Traffic Management Plan – Site Establishment and Stage 1

N217
BR COP

Client:	Transport for NSW – Sydney Metro
Title:	BARANGAROO STATION
Subtitle:	Traffic Management Plan – Site Establishment and Stage 1
Owner / Approver:	Planning & Environment Manager / Project Director
TB Document Reference:	SMCSWSBR-BWC-SBR-TF-PLN-000025
TB Revision:	00
Document Path:	BESIX Watpac // Construction NSW (G:)

Report Date	29 July 2021	References	
Road Safety Audits Reference	RSA-11189	Desktop Audit General Scope	The scope of the audit is to assess the plans on their merits and in the context of the road environment, with standards and guidelines as a reference.
		<div style="display: flex; justify-content: space-between;"> <div style="width: 45%;"> <p>Senior Road Safety Auditor CP(Eng, RPEQA, NER, BE (Civil))</p> </div> <div style="width: 45%; background-color: black; color: white; padding: 5px;"> <p>Senior Road Safety Auditor CP(Eng, RPEQA, NER, BE (Civil)), BB (Bus. Admin.)</p> </div> </div>

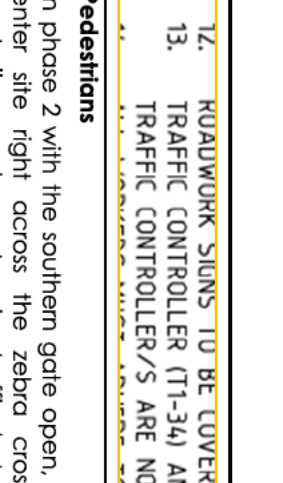
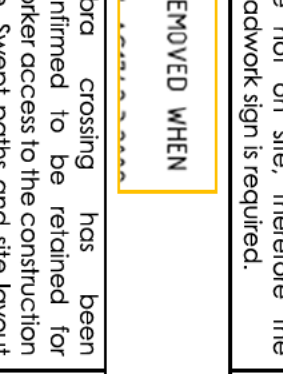
Audit Point		Treatment Option		Waipac Construction (NSW) P/L Responder:		Status
2.	<p>Adjacent Sites</p> <p>The CTMP section 6 page 33 states that the Project will ensure that signs are "Not contradictory to existing signs or markings".</p> <p>The intent of this note is to ensure that signs don't overlap with / contradict / clutter with other sites / signs.</p>	<p>Ensure this note has been applied and in particular to the southern end signage (in blue).</p> <p>Risk: Low</p>	<p>The TGS reviewed is an overview version that will form the basis for detailed TGS prepared by the appointed traffic control company. Nonetheless a note has been added to the TGS for signs to be coordinated with other work sites. A similar note has also been added to Section 3.8.1 of the TMP</p>			Closed

Audit Point		Treatment Option		Walpac Construction (NSW) P/L Responder:		Status
3.	<p>The TGS note 13 states that the some of the signs will be covered/removed after work hours, but does not include reference to the symbolic roadworker sign.</p> <p>Guidelines and common industry practice also see this sign being covered outside of work hours. Refer RMS TCWS V 5.0 Section 5.2.3 (and AS1742.3:2019).</p>	Review.		<p>Note 12 on the TGS states: "Roadwork signs to be covered or removed when workers are not on site" – this has been separated from Note 13 as works may continue when traffic controllers are not on site, therefore the Roadwork sign is required.</p>		Closed
